South Texas Project Electric Generating Station P.O. Box 289 Wadsworth, Texas 77483

December 28, 2003  
NOC-AE-03001659  
10CFR50.90

South Texas Project  
Unit 2  
Docket No. STN 50-499  
Supplement 3 to Proposed Emergency Change to Technical Specification 3.8.1.1 Note 12

**Response to Request for Additional Information**

**Figure 1**  
**Photograph of the Fracture Surface**

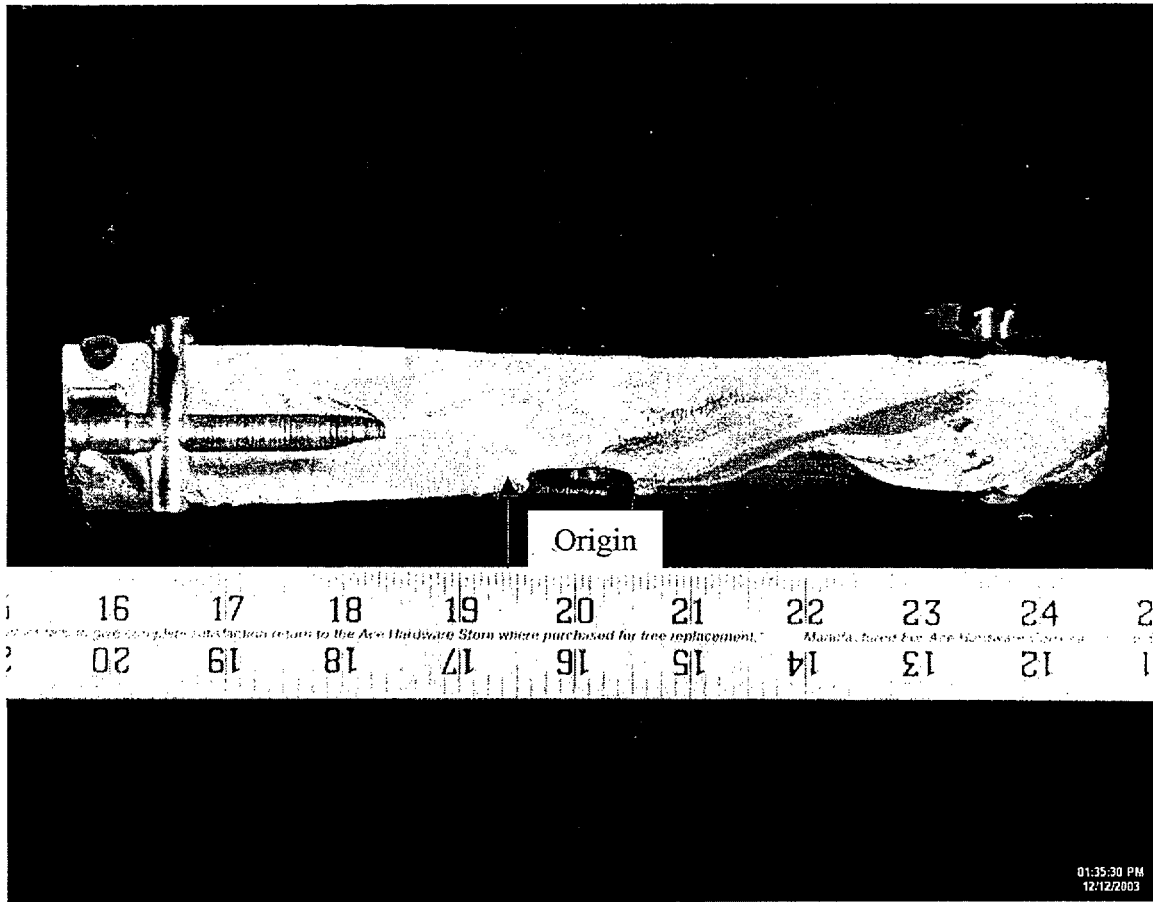
1. **Provide the critical crack size that the master connecting rod will fail due to high cycle fatigue. Give length & depth or aspect ratio.**

As shown in the attached photograph of the fracture surface (Figure 1), the critical crack size is about 7 inches in length by about 1 inch in depth (the thickness of the ligament). This determination is based on empirical data obtained from examination of the fracture face.

**Figure 5**  
**Fatigue Beach Marks**

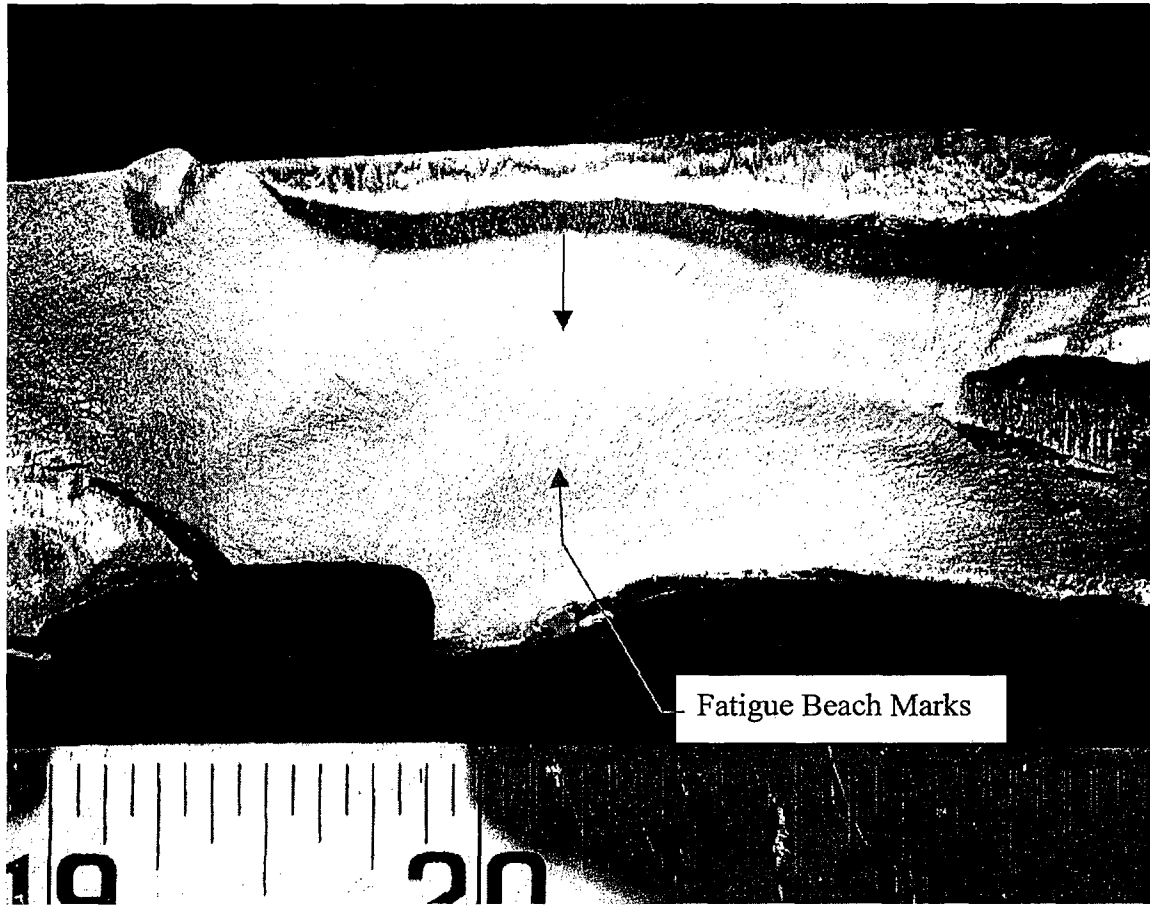
2. **Provide a calculation that demonstrates that the minimal detectable crack size will not grow to the critical crack size and fail due to high cycle fatigue during the proposed interval between NDE inspections. The calculation needs to account for the possibility that an accident can occur prior to the end of the inspection interval and that the diesel will perform its mission without failure. The calculation should describe the results, the assumptions and inputs and method used so that an independent reviewer can verify the conclusions.**

A photograph of the fracture surface (Figure 5) was used to measure the crack growth and the number of beach marks. The photograph has a ruler scale at the bottom of picture. The measured crack growth for one group of beach marks is about 3/16 inches. There are 13 beach marks in this length. Thus on average, the fatigue crack grew 0.014 inch between two successive beach marks. This region of beach marks is about 1/2 inch from the origin. Each of these equivalent beach marks was associated with a normal monthly surveillance run, and in the relevant time frame that run was just over 4 hours in duration. Thus the measured crack growth rate per stress cycle,  $da/dN$ , is about  $0.2 \times 10E-6$  inches per cycle. The stress cycles are counted from the peak stresses when the master connecting rod is at TDC at the end of its exhaust stroke, 300 cycles per minute at 600 rpm.

As noted above, the February 27, 1990, Battelle report provided the coefficient for the Paris Law Equation for this material, based on tests of actual connecting rod steel. Using this equation and inserting  $da/dN = 0.2 \times 10E-6$  inches per cycle, the  $\Delta K$  for the crack at that depth was computed to be 11.13 ksi  $\sqrt{\text{in}}$ . The  $\Delta K$ 's for other crack depths between 0.1 inch and 1 inch were computed using the standard fracture mechanics relationship between stress intensity factor  $K$ , stress  $\sigma$ , and crack depth  $a$ :
